1 Review of CWM Radioactive Sampling Program In the Proposed RMU-2 Development Areas

November 2014

On behalf of Niagara County

Marvin Resnikoff, Ph.D.

Fig. 1. Surface Gamma Survey 1971 - 1972

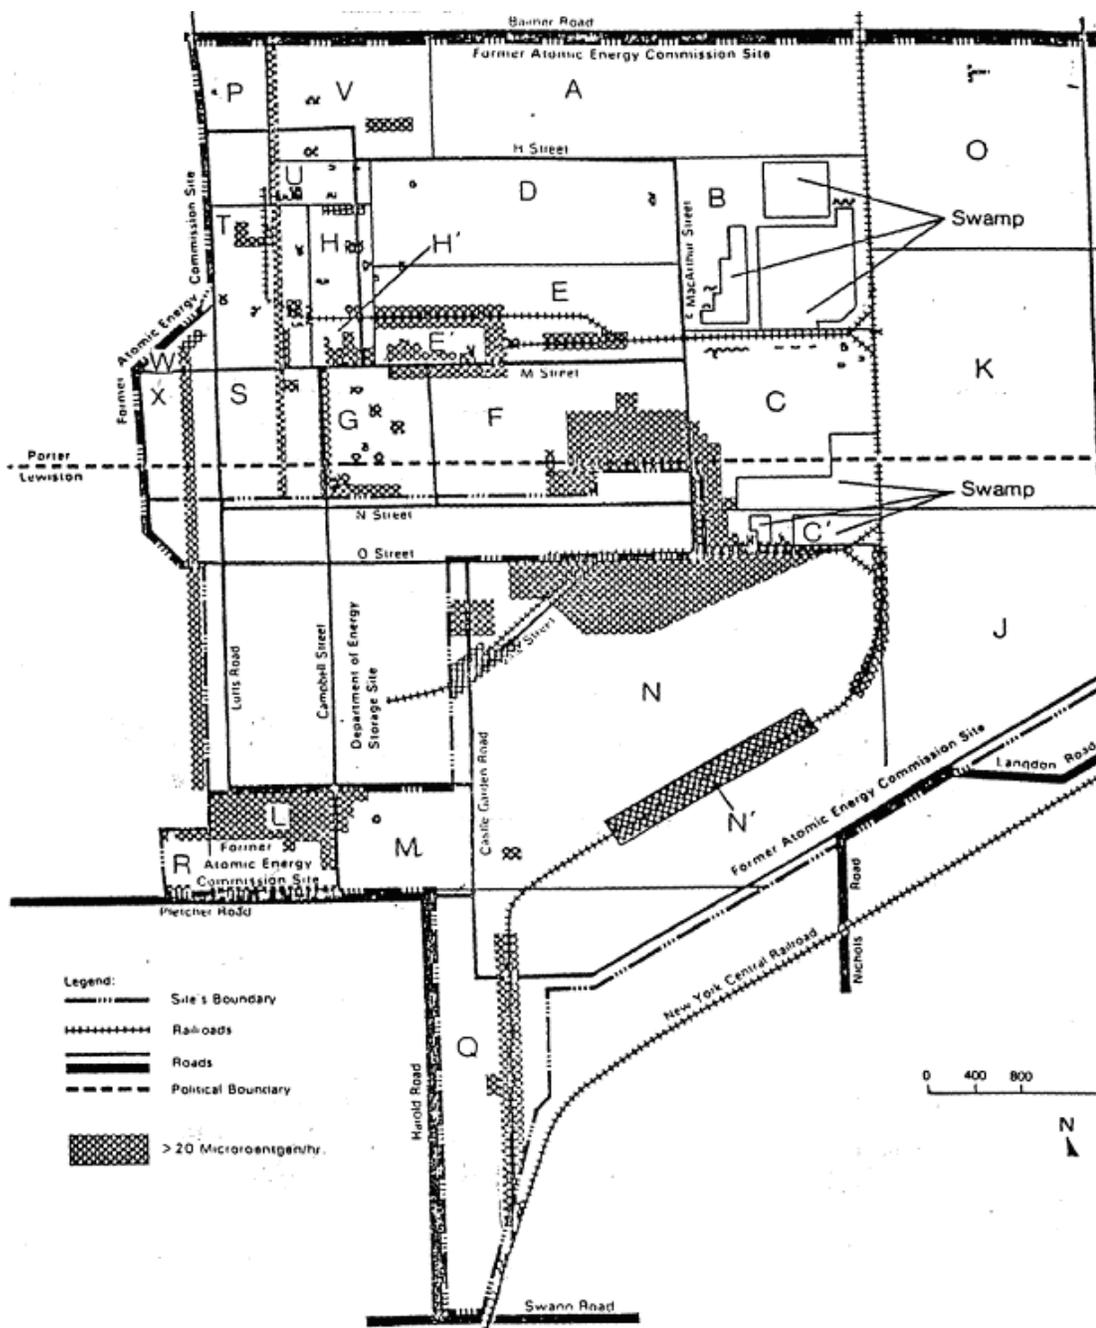
Since 1972 when this survey was taken, further decontamination, in vicinity properties C and F may have occurred, and also earth was moved to construct Fac Pond 8.⁹ A 1978 report refers to the “proposed temporary use of No. 8 area as a treated waste lagoon.”¹⁰ More recently, 85 cubic yards of contaminated earth were removed from Fac Pond 8, with composite radium-226 concentrations of 191 pCi/g,¹¹ despite the fact that gamma surface surveys could not detect this contamination, as we discuss below.

The vicinity properties are shown in Fig. 1. The vicinity properties, superimposed on the footprint of RMU-2, are shown in Fig. 2. As seen in Fig. 2, the vicinity properties associated with RMU-2 areas of disturbance are C, D, E, E' and F. Maps that show the location of contaminated soil within each Vicinity Property are not included here, but are contained in the attached report, RWMA, 2009.
